*Energy Harbor Nuclear Corp.
Beaver Valley Power Station
P.O. Box 4
Shippingport, PA 15077*

June 14, 2021
L-20-295

Beaver Valley Power Station, Unit Nos. 1 and 2
Docket No. 50-334, License No. DPR-66
Docket No. 50-412, License No. NPF-73
Emergency Plan Amendment Request

Subject: Request for licensing action to revise the Beaver Valley Power Station, Emergency Preparedness Plan to reduce on-shift staff positions, extend augmented Emergency Response Organization (ERO) response times, and re-align augmented ERO response positions.

FIGURE 5.76

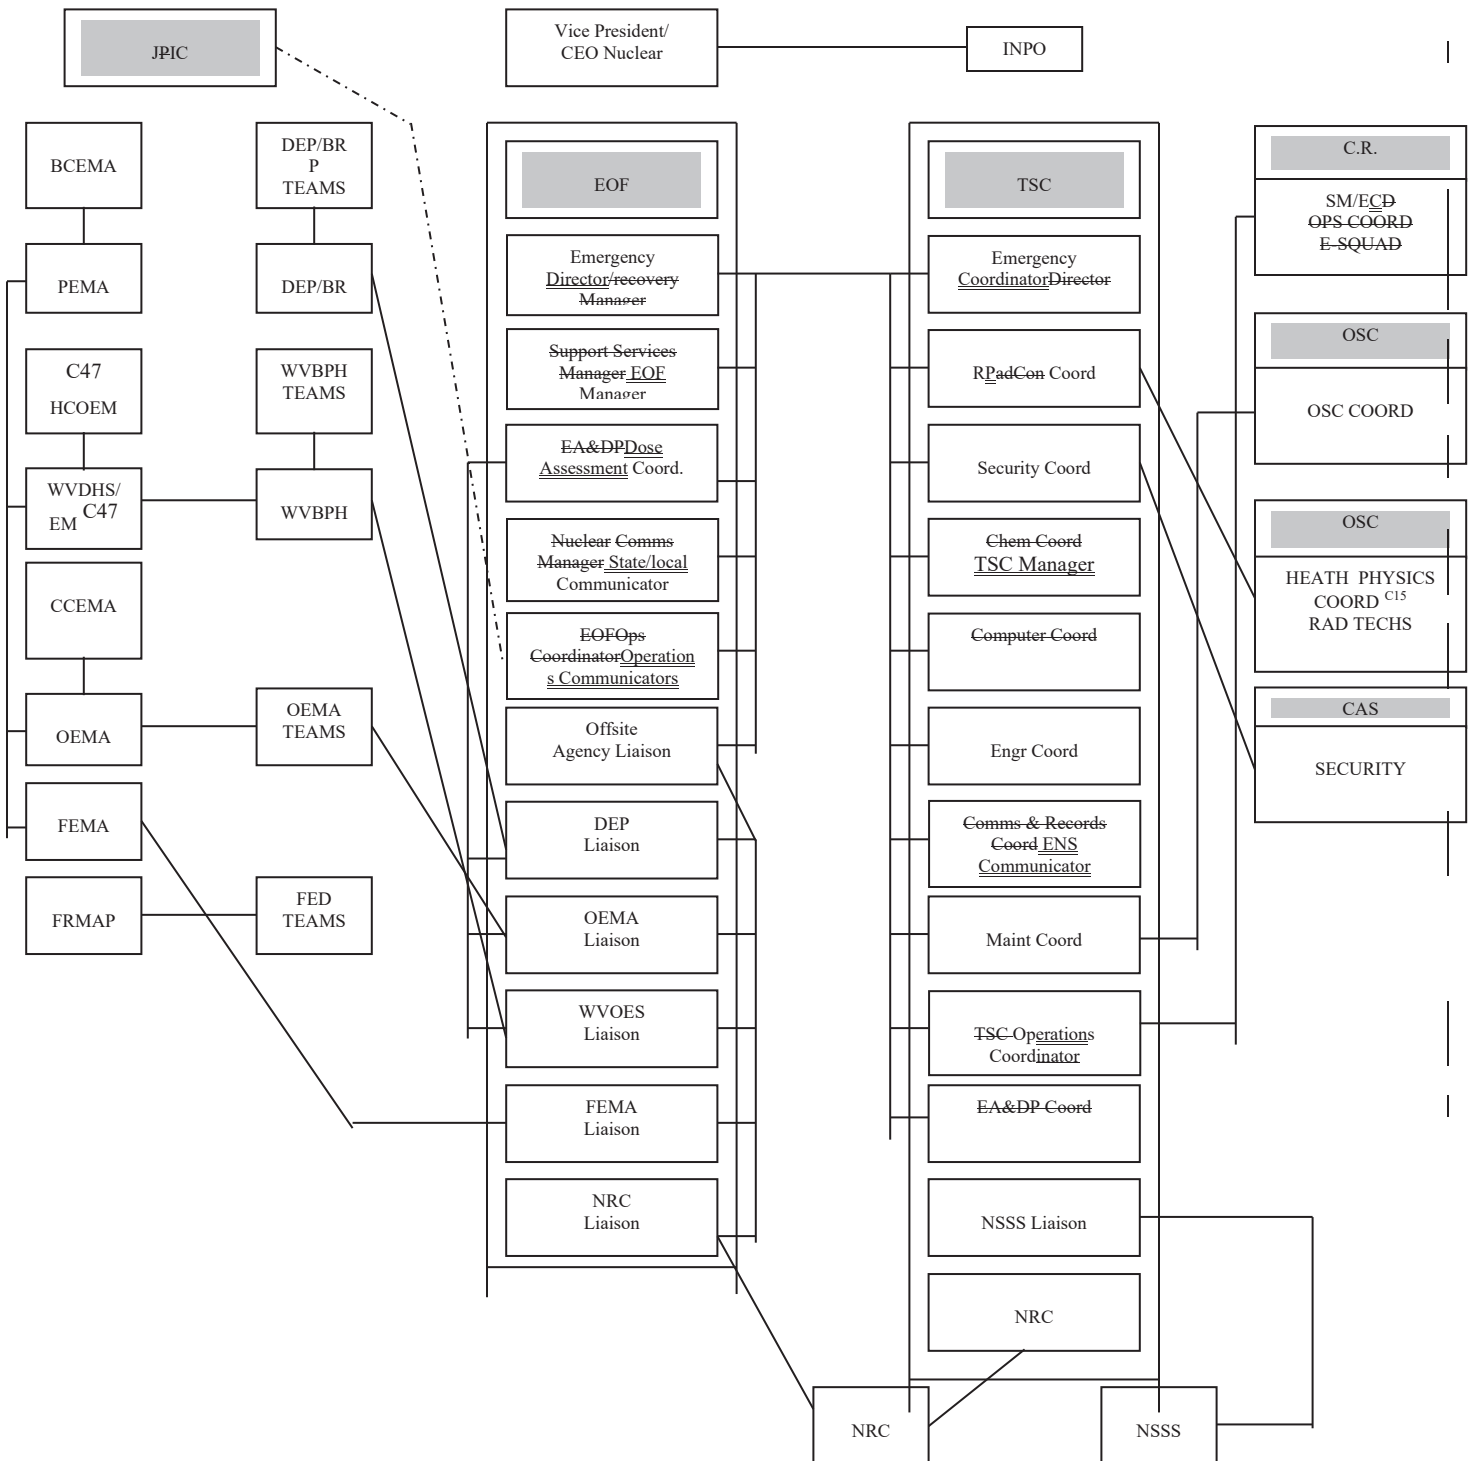
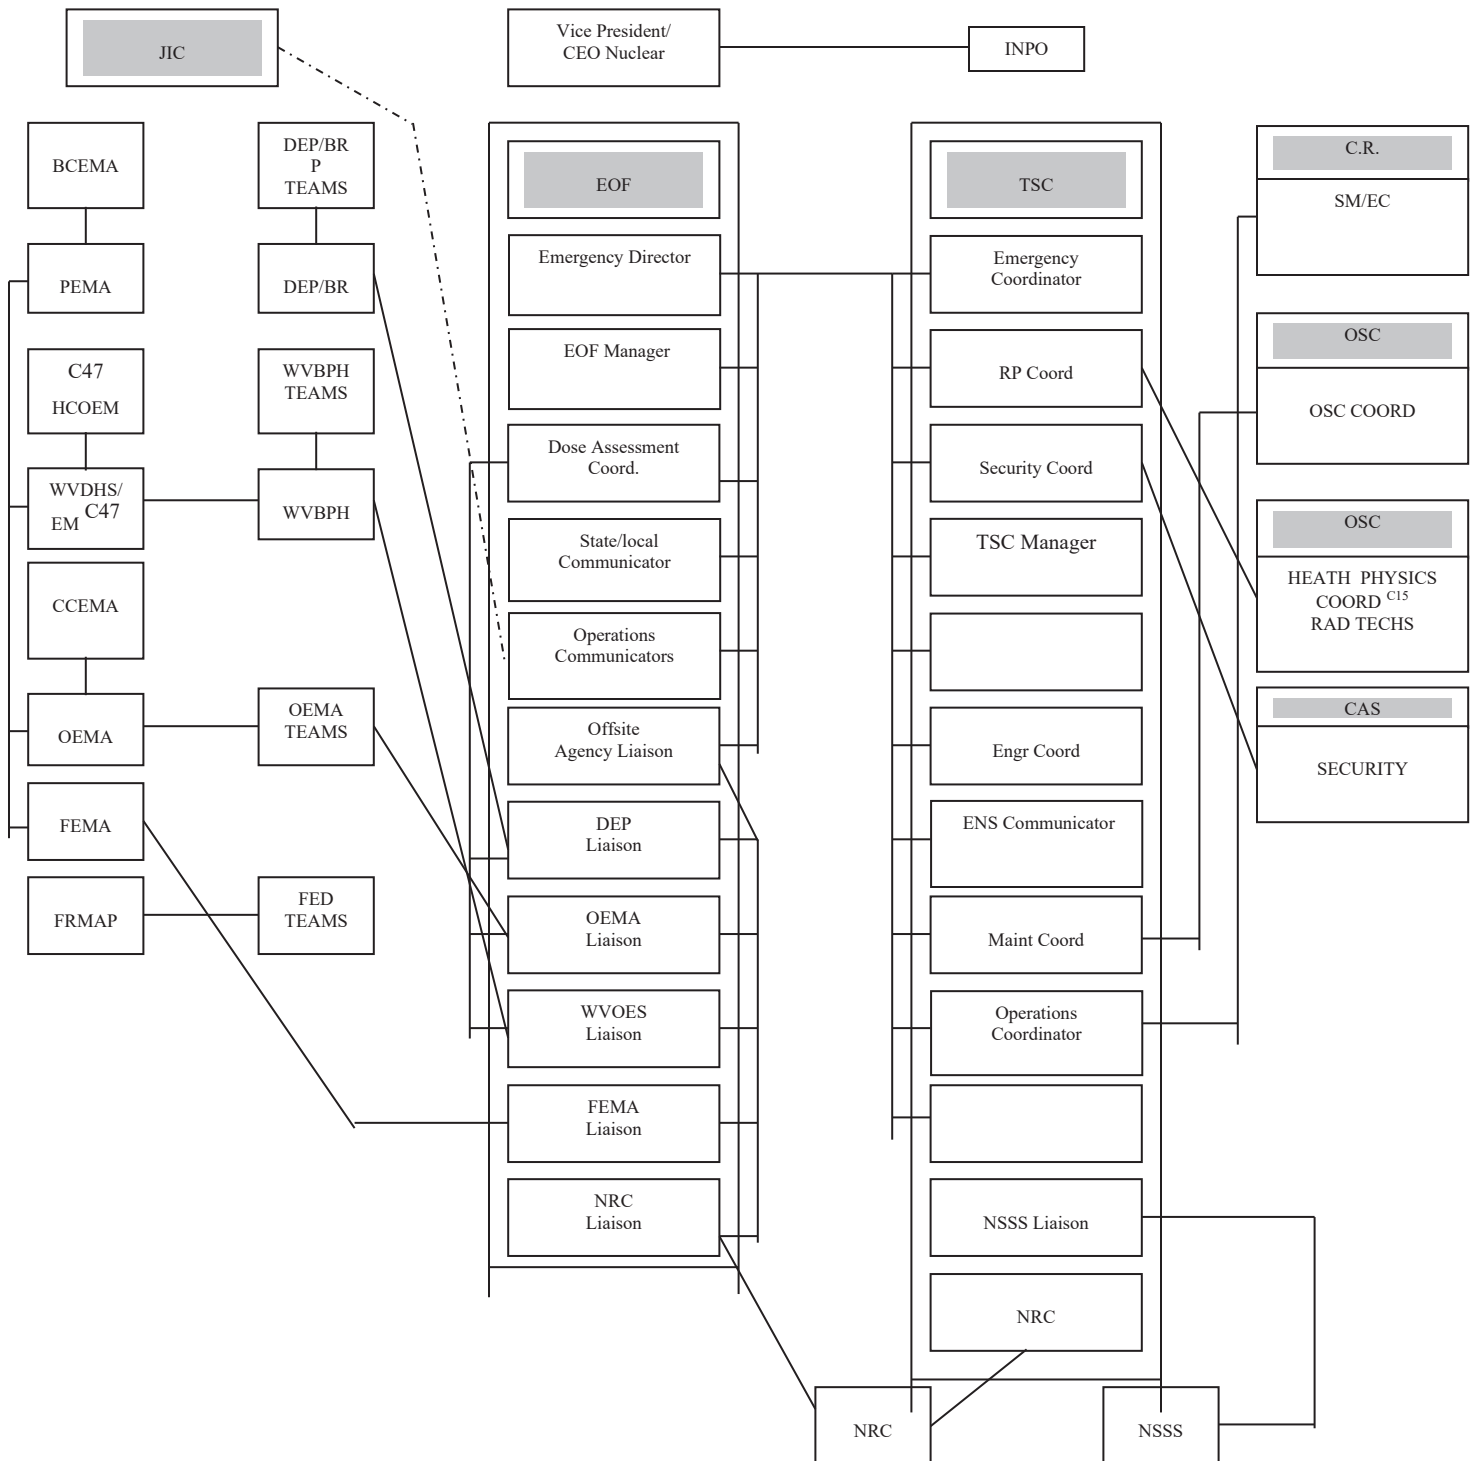
- sss. Figure 5.7 (no title) revised to reflect position title changes as previously described and renumbered from Figure 5.6 (no title) to Figure 5.7 (no title) to reflect inclusion of OSC staffing as EPP Figure 5.4.
